Questions and Answers Updated January 14, 2025: RFP 25-23 Internal Connections (Hardware/Related Services) See photos below:

#### BREWSTER IDF 4

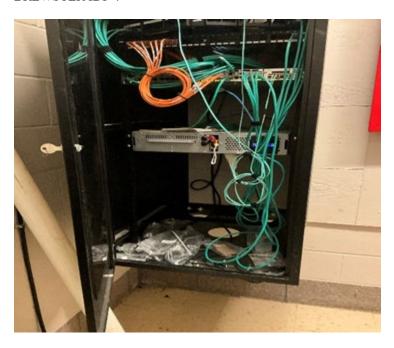
- c. Q: If possible, would you be able to provide pictures of the cabinets plus re-mount points?
  - A. Yes, see attached photos of the 9 IDF wall mounted cabinets that will be replaced at the four sites. All new wall mounted cabinets will require a mounted backboard for support and safety. See attached photos for reference below.

- d. Q: Will any VLAN changes be needed?A: No.
- e. Q: Are backboards in place to mount the cabinets, and if not, who will provide the backboards?
  - A: The vendor will provide and install the backboards for all new wall mounted cabinets.
